HISTORIC AND DESIGN REVIEW COMMISSION

HDRC CASE NO: 2019-219
ADDRESS: 421 PIERCE, Corner of E Carson, Pierce and Colita
LEGAL DESCRIPTION: NCB 1265 BLK 1 LOT 5 & S 51 FT OF 4
ZONING: RM-5, H
CITY COUNCIL DIST.: 2
DISTRICT: Government Hill Historic District
APPLICANT: Pegy Brimhall
OWNER: Phil Hooker/1807 LAND & CATTLE COMPANY LLC
TYPE OF WORK: Construction of 5, residential structures and rehabilitation of an existing, 2-story residential structure
APPLICATION RECEIVED: April 15, 2019
60-DAY REVIEW: June 14, 2019
CASE MANAGER: Edward Hall
REQUEST:

**Historic and Design Review Commission
 Design Review Committee
 Report & Recommendation**

1 PIERCE ELEVATION STUDY DIAGRAM
G0.02

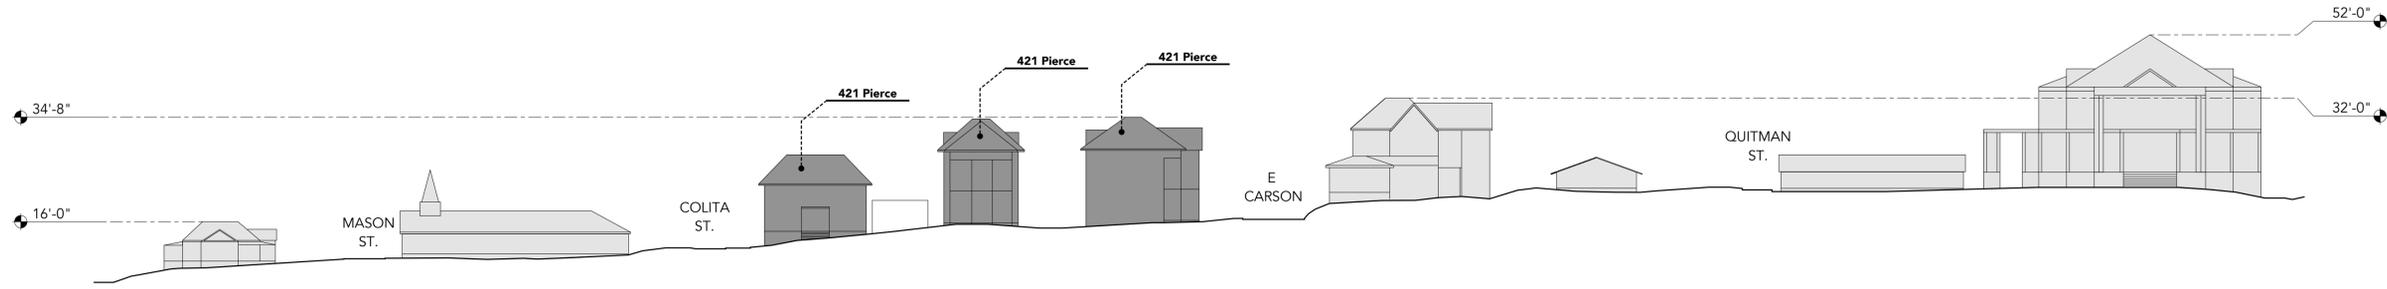
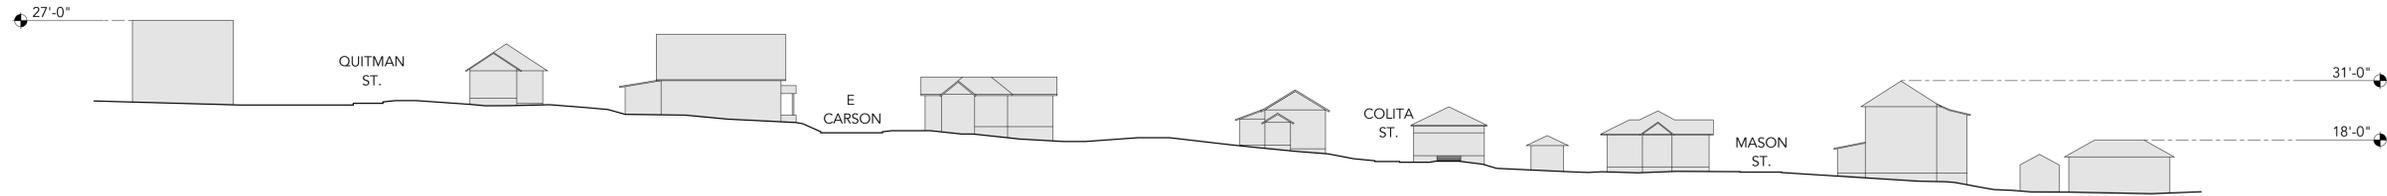
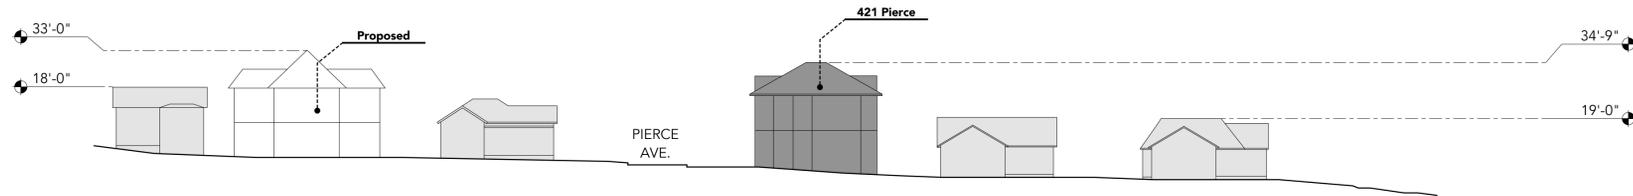
- h. **SCALE & MASS** – The applicant has proposed street elevation diagrams of Pierce, E Carson and Colita, which note the significant change in grade from north to south, which impacts the perceived heights and massing of the proposed new construction.

- i. **SCALE & MASS (Carson)** – Per the Guidelines for New Construction 2.A.i., a height and massing similar to historic structures in the vicinity of the proposed new construction should be used. In residential districts, the height and scale of new construction should not exceed that of the majority of historic buildings by more than one-story. This block of E Carson features seven historic structures, three of which feature multiple stories in height. The applicant has proposed a height on E Carson of approximately thirty-three (33) feet. Staff finds that the proposed height should be reduced to heights comparable with those found on the block. More than one story in height may be appropriate; however, the proposed height should be consistent with adjacent historic structures.

- j. **SCALE & MASS (Pierce)** – Per the Guidelines for New Construction 2.A.i., a height and massing similar to historic structures in the vicinity of the proposed new construction should be used. In residential districts, the height and scale of new construction should not exceed that of the majority of historic buildings by more than one-story. The applicant has proposed to construct a two story structure with occupied attic space on Pierce. The adjacent historic structure features an overall height of approximately twenty-five (25) feet in height. The applicant has proposed an overall height of approximately thirty-four (34) feet. Staff finds that new construction featuring more than one story in height is appropriate at this location; however, the proposed height should be consistent with that of the historic structure on this block.

- k. **SCALE & MASS** – Generally, staff finds that the proposed scale and mass of the multi-story structures is greater than what is found historically in the immediate vicinity. Staff finds that if the ground level parking which is currently incorporated into the design of each structure was removed, the overall massing and height of each structure could be reduced.

- i. That the applicant ensure that the proposed structure on E Carson features a setback that is greater than the historic structures on the block.

- ii. That the applicant reduce the proposed massing for the proposed structure on E Carson to be comparable with the two story structures on the block.

- iii. That the applicant reduce the proposed massing for the proposed structures on Pierce and Colita to not exceed the existing, two story historic structure at that location.

1 CONSTRUCTION PLAN
G0.03 SCALE 1" = 10'-0"

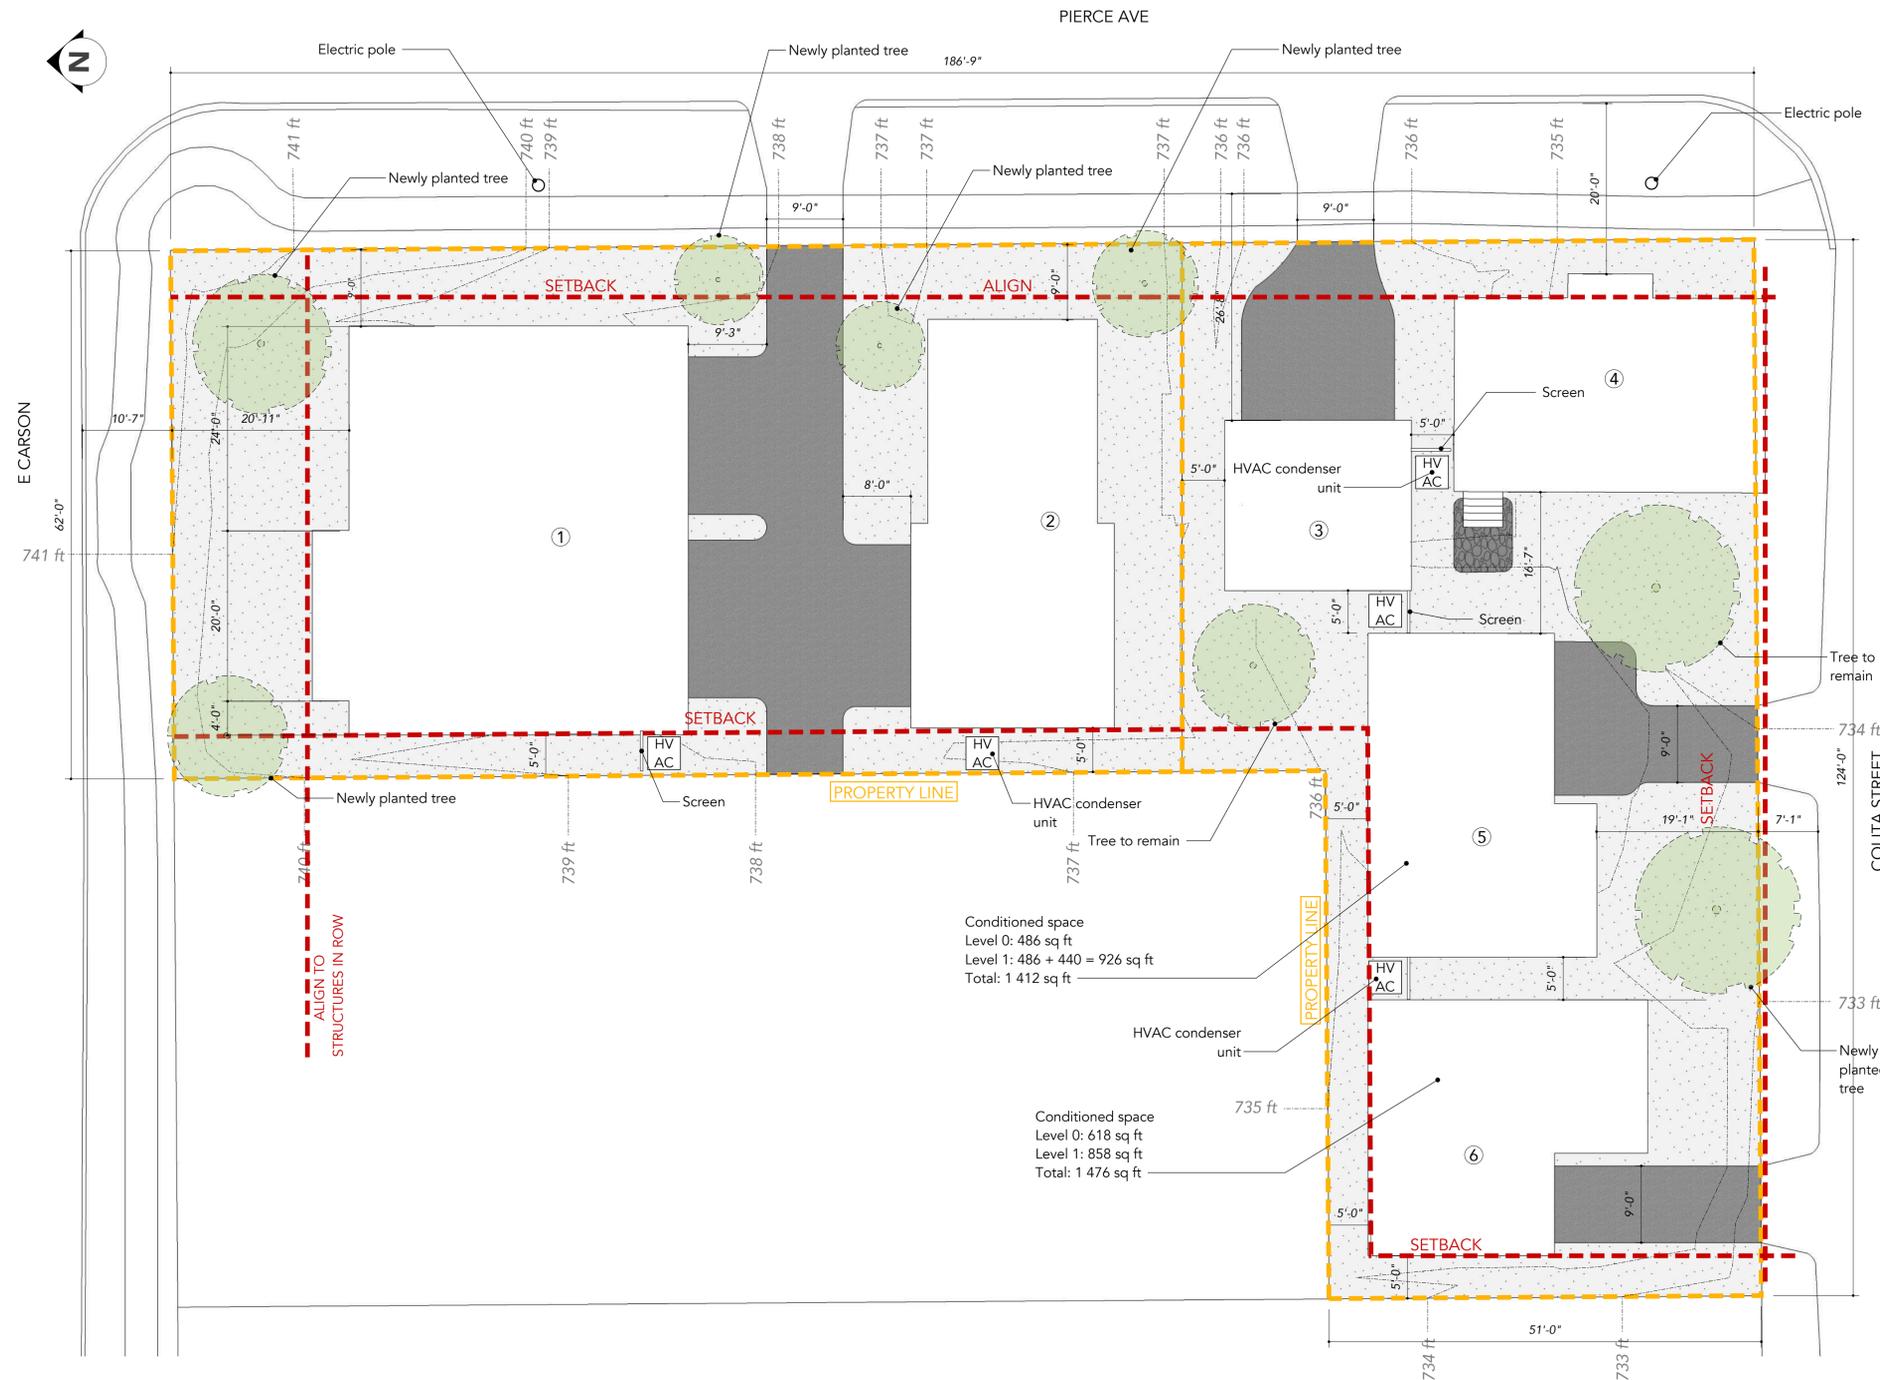
- p. **LOT COVERAGE** – Per the Guidelines, the building footprint for new construction should be no more than fifty (50) percent of the size of the total lot area. The applicant has proposed to introduce a large amount of square footage that currently is not typical of the district. Staff finds that the applicant should confirm that the proposed building to lot ratio does not exceed fifty (50) percent.

- z. VEHICULAR ACCESS – The applicant has proposed vehicular access to the proposed structures in the form of two new driveways on Pierce and one on Colita. The applicant has proposed for each driveway to feature an apron width of non (9) feet; however, all but one of the proposed driveways feature profiles and widths that are not typical of those found historically in the district.

- aa. SITE PAVING – The applicant has proposed an amount of on-site paving that is atypical of what is found historically in the district. Staff finds that the applicant should reduce the overall amount of concrete on site. Pervious materials should be considered for driveways and site parking.

- bb. LANDSCAPING – The applicant has provided an overall site plan with some landscaping elements. Staff finds

that both a landscaping plan and tree preservation plan be submitted for review.

- vi. That the applicant provide information regarding lot sizes and footprints to confirm that the proposed new construction does not cover more than fifty (50) percent of the lot.

- ix. That all mechanical equipment be screened from view at the public right of way.
- x. That the applicant incorporate driveway designs that are typical with those found historically in the district.

- xi. That the applicant submit a landscaping and tree preservation plan.

Sheet Contents:
Elevations, Existing
House

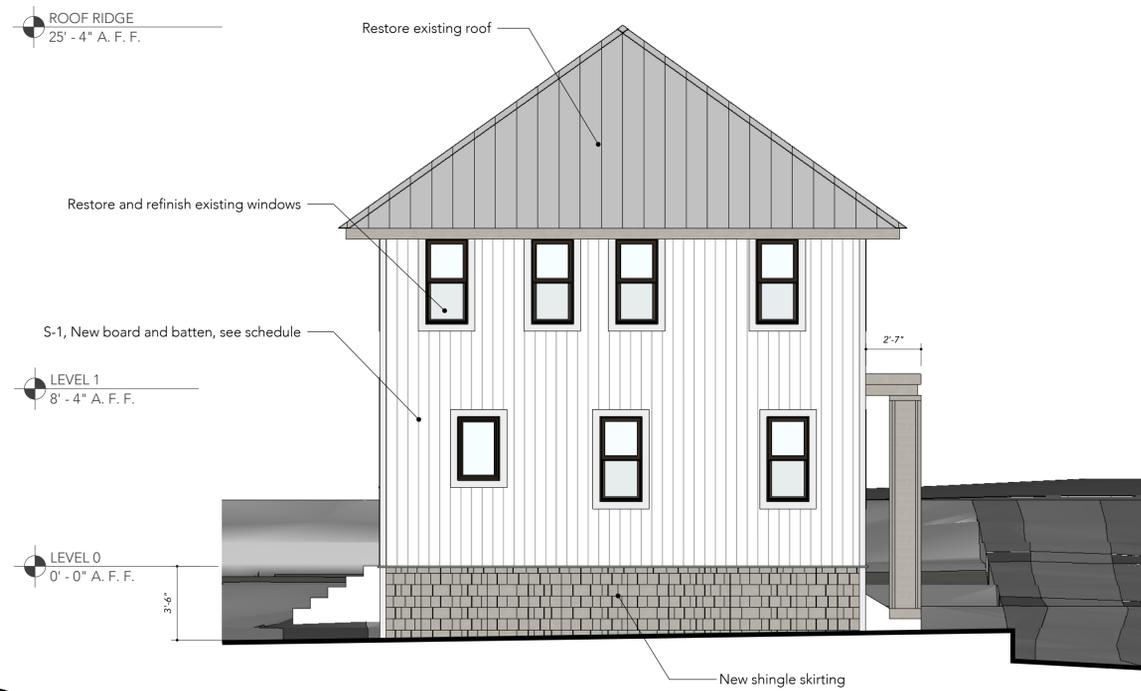
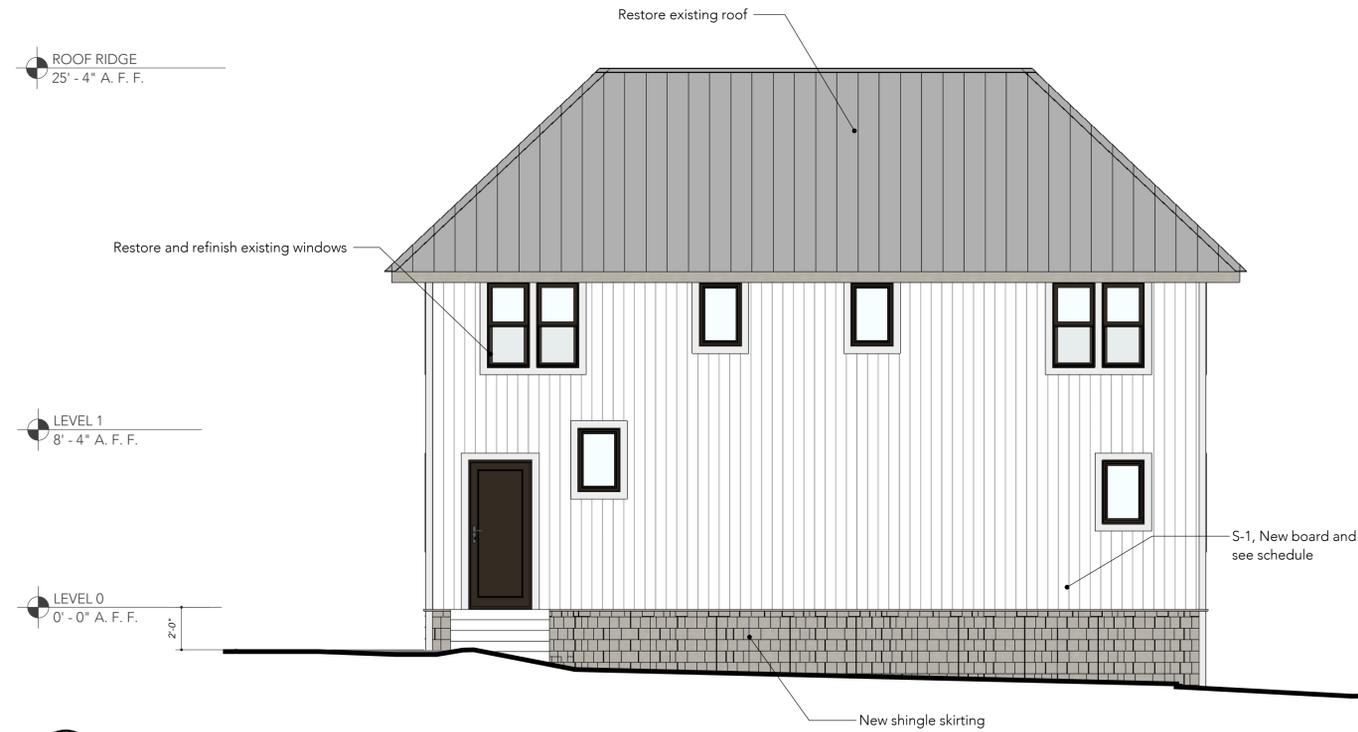
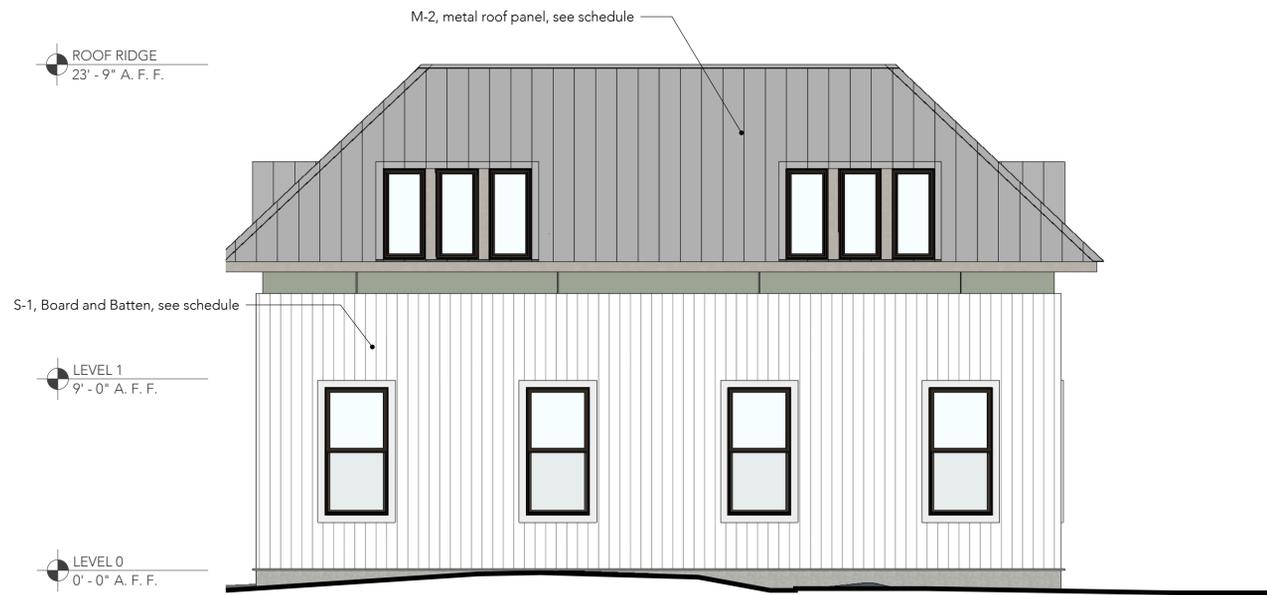
- v. REHABILITATION (421 Pierce) – The applicant has proposed to rehabilitate the historic structure located at 421 Pierce, which includes the removal of the existing, non-original siding and the installation of board and batten siding, the restoration of the existing wood windows and the installation of new foundation skirting. Staff finds that the applicant should confirm the original siding material (potentially existing under the non-original) and match it during rehabilitation. Additionally, staff finds that a composite siding skirting should be installed as opposed to shingle skirting, as shingles are not found historically in the district as a skirting material.

- w. EXTERIOR MODIFICATIONS (421 Pierce, front facade) – The applicant has proposed exterior modifications to the historic structure at 421 Pierce which includes the removal of the existing, non-original porch and street facing door and the construction of a new porch and centered front door. The Guidelines for Exterior Maintenance and Alterations 7.B.v. notes that porches should be reconstructed based on accurate evidence of the original, such as photographs. If no such evidence exists, the design should be based on the architectural style of the building and historic patterns. This structure first appears on the 1951 Sanborn Map and does not feature a front porch. Staff finds that the centering of the porch and door on the front façade may be appropriate; however, staff finds that the porch should not be recessed into the existing front façade, as currently proposed.

- x. EXTERIOR MODIFICATIONS (421 Pierce, rear façade) – The applicant has proposed modifications to the rear façade that includes the removal of a second story, rear door and a ground level, rear door. Both doors will be replaced with windows. Generally, staff finds these modifications to the rear façade to be appropriate.
